## Manor Road, Richmond

### Technical Note 1: Model Review and Response to LLFA Comments

12<sup>th</sup> July 2023

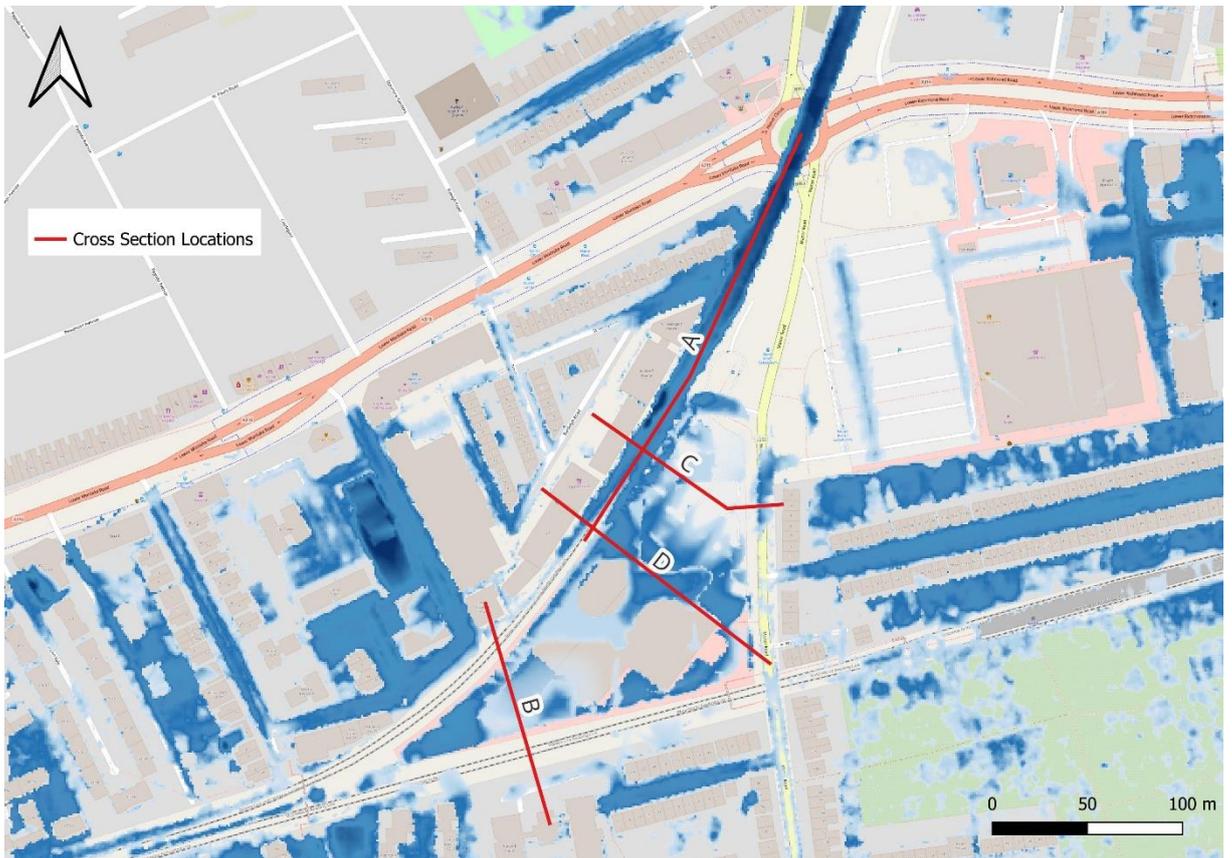
**The hydraulic modelling report has been reviewed, with specific comments provided in the attached table.**

- 2.1 As outlined above, Brookbanks have undertaken a detailed review of the previous modelling for both the pre- and post- development modelling files. This is to act as a further peer review of the works completed to provide further confirmation that the modelling, as confirmed by GLA, remains appropriate and a summary of the findings of this review are outlined below.

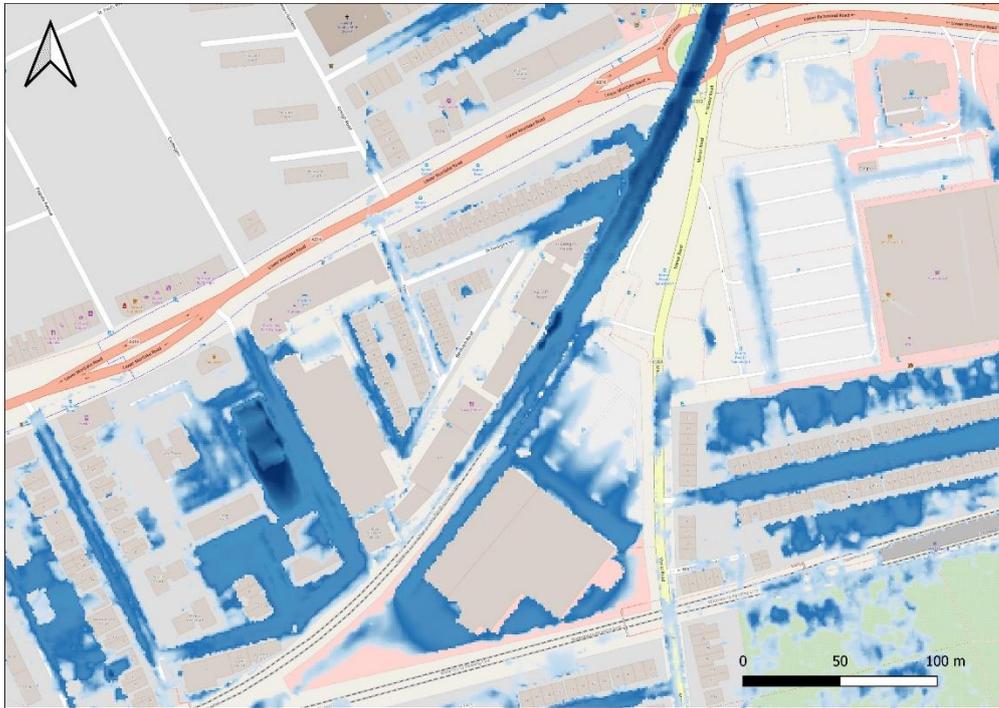
- 2.21** The outputs from this scenario demonstrate that when including the onsite drainage the flood extents and depths are significantly reduce from the baseline scenario AND the ‘no drainage’ post development scenario details. To illustrate this the below figure shows both the baseline and the ‘post development drainage’ option.

As can be seen there is a significant reduction and specifically to and along the railway line.

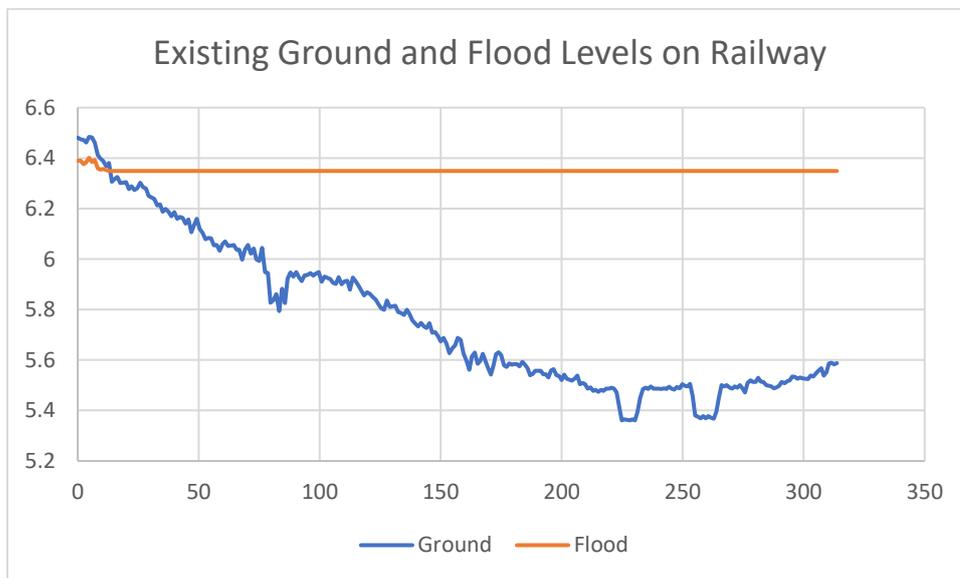
**2.23** In the event that the above does not provide significant justification to address the conservative nature of the modelling and the impact of including the on-site drainage on third party increase (i.e. only a betterment) and looking at the comment on a site specific level, it should be noted that the area where increased flooding is predicted is within an existing low point occupied by a railway line. From available topographical data, see below, this area is naturally low compared to the surrounding area and acts as a bowl and is shown in the baseline scenario (i.e. no development) to a maximum depth of >1000mm, see below.

**2.24** This therefore confirms that this area is currently liable to extensive flooding and these depths would have a significant impact on the operation of the railway in any such event – the baseline modelling has confirmed that the existing hazard along this section of the railway is ‘Significant’ in line with DEFRA 2320 guidance document and whilst the values increase by a small amount as a result of the proposals (1.29 in baseline to 1.31 in the proposed) the railway remains unchanged and at a ‘significant’ risk, see below. As such this would not impact the operation of the railway given it would already be under water and operational procedures would have been enacted by the rail provider and this is unaffected as a result of the development.

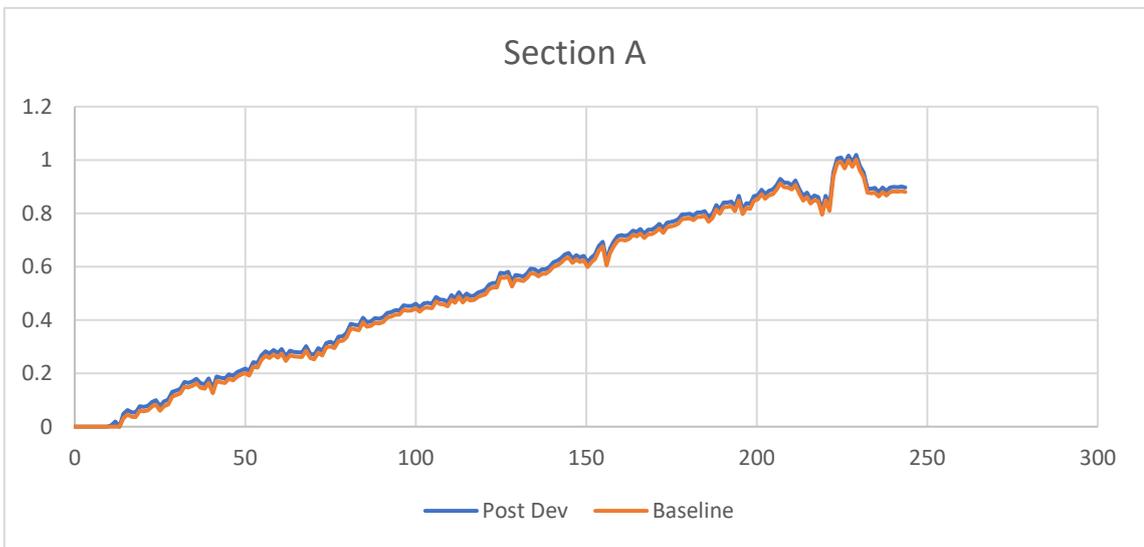
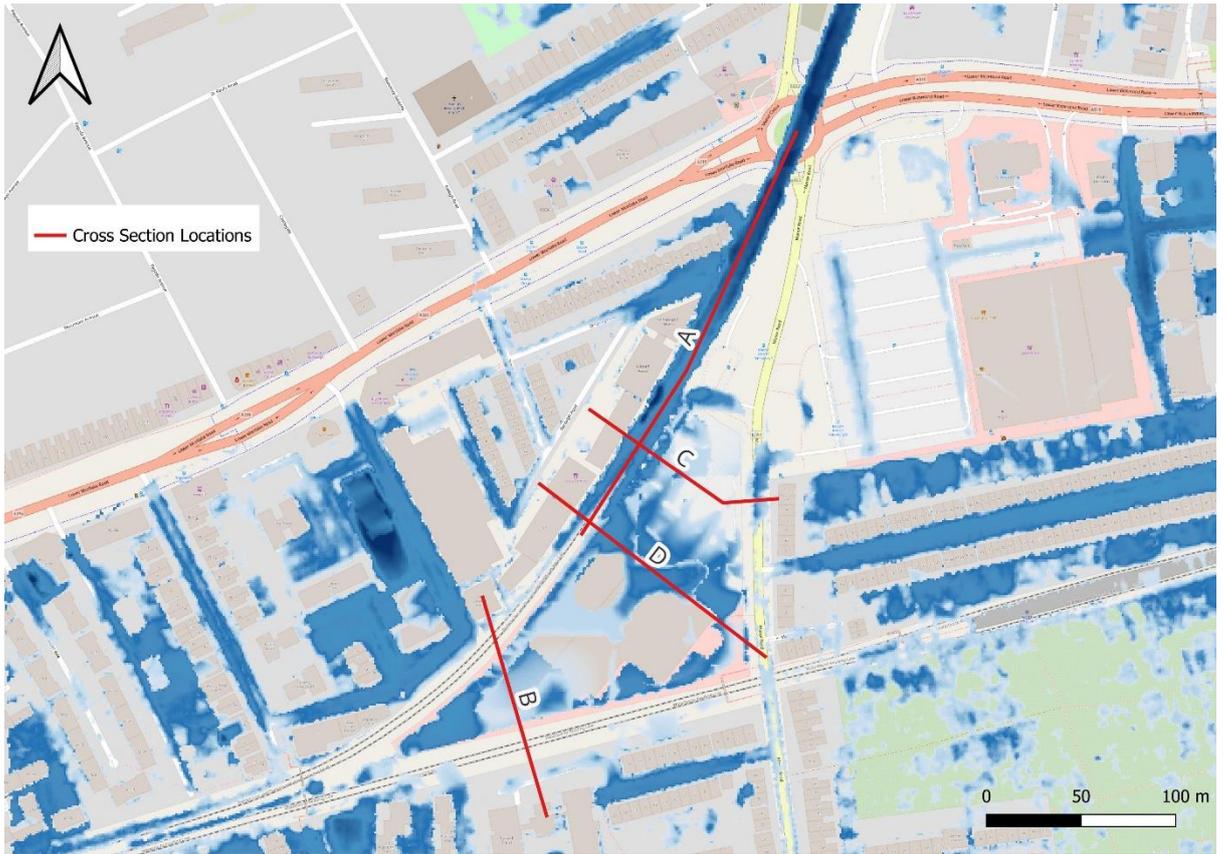
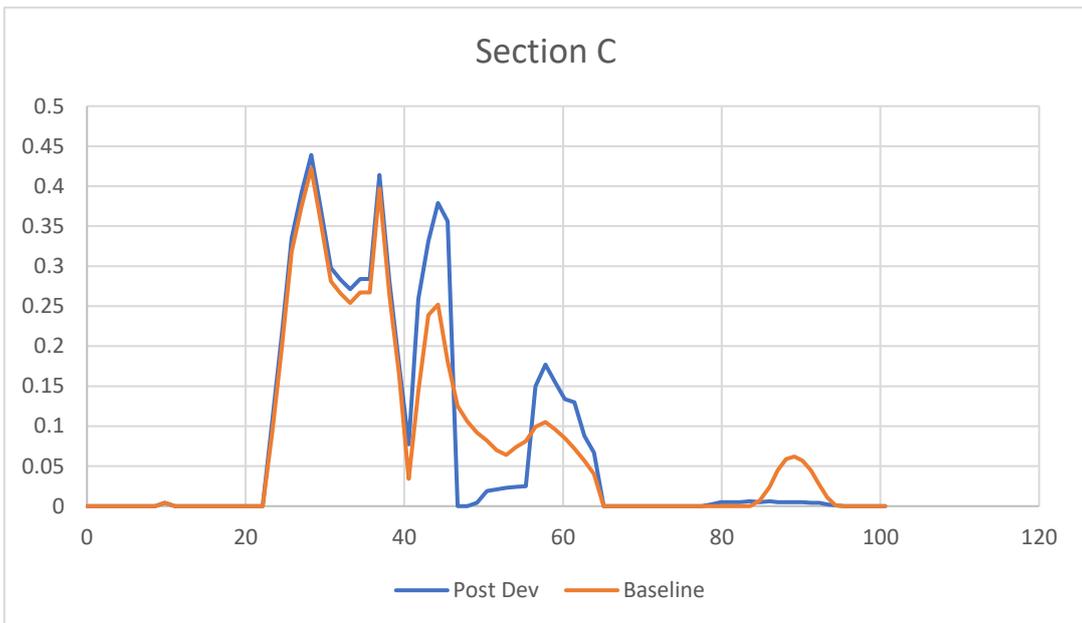
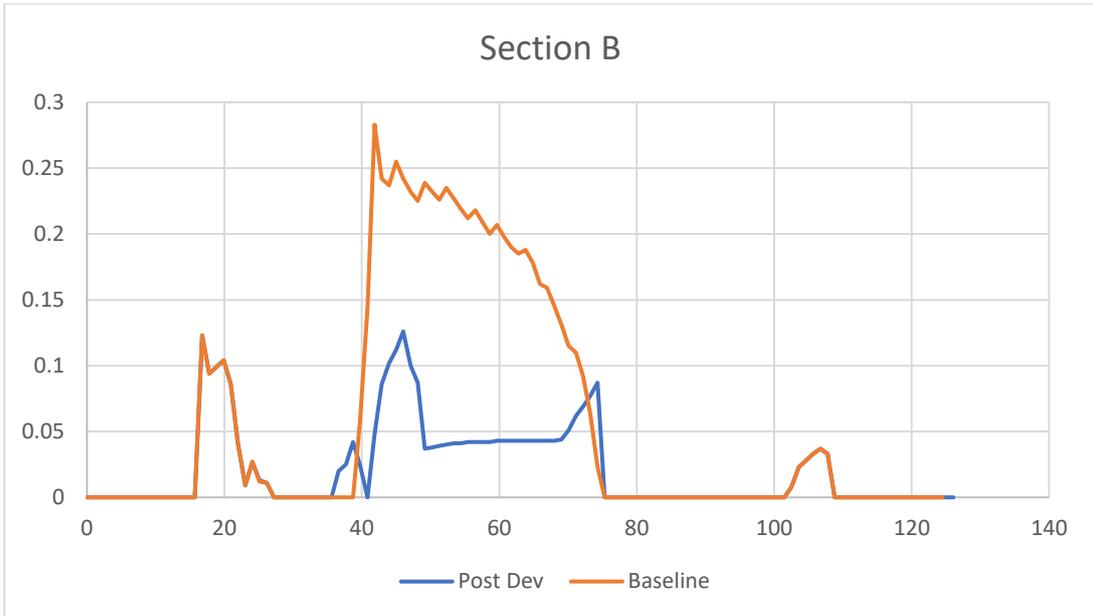
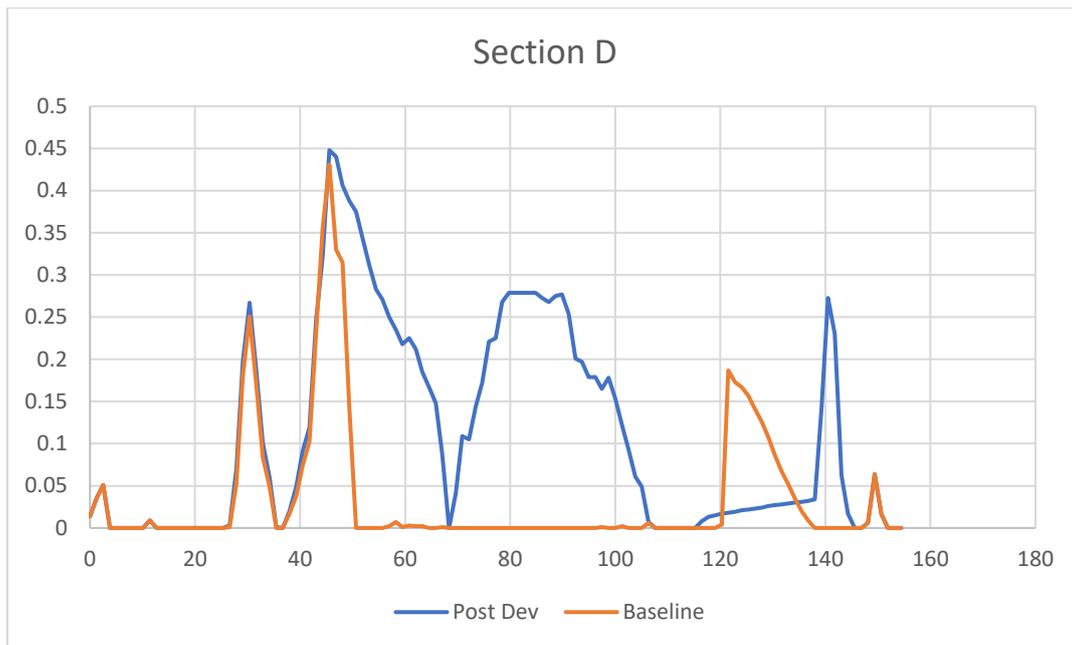
**GLA Comment: Depth change figures should be provided to show the extent of the impacts.**

- 2.31** This point has previously been discussed with GLA and it was the view that the modelling files previously provided by Hydrock allowed the reviewers to undertake their own review of the outputs to avoid being restricted to points chosen by those producing the drawings. This is often an approach adopted to allow complete transparency for the review. However this comment indicates that depth change figures are required. As such, the below figure (as that above) provides the location of four cross sections that have been taken through the site and surrounding area along with associated graphs taken from the approved model results to show the difference in baseline and proposed flood depths. All of these graphs have been generated for the agreed design event of the 1 in 100 year plus 40% allowance for climate change event.

**2.32** As can be seen from the above figure and associated graphs, flood levels throughout the application boundary are shown to increase in areas with most being within the site boundary – Section B, C and D. These have been purposefully designed to mitigate / reduce any off-site impact of the development. These areas are therefore shown as functioning correctly by providing more storage than the existing scenario.

**2.33** The above figures and graphs also confirms that with the exception of a small area of the railway no other increases in flood depth are predicted section on the railway where a maximum increase of 23mm is shown. It should again be noted that the existing depth is ‘significant’ and a maximum of 1000mm in depth.
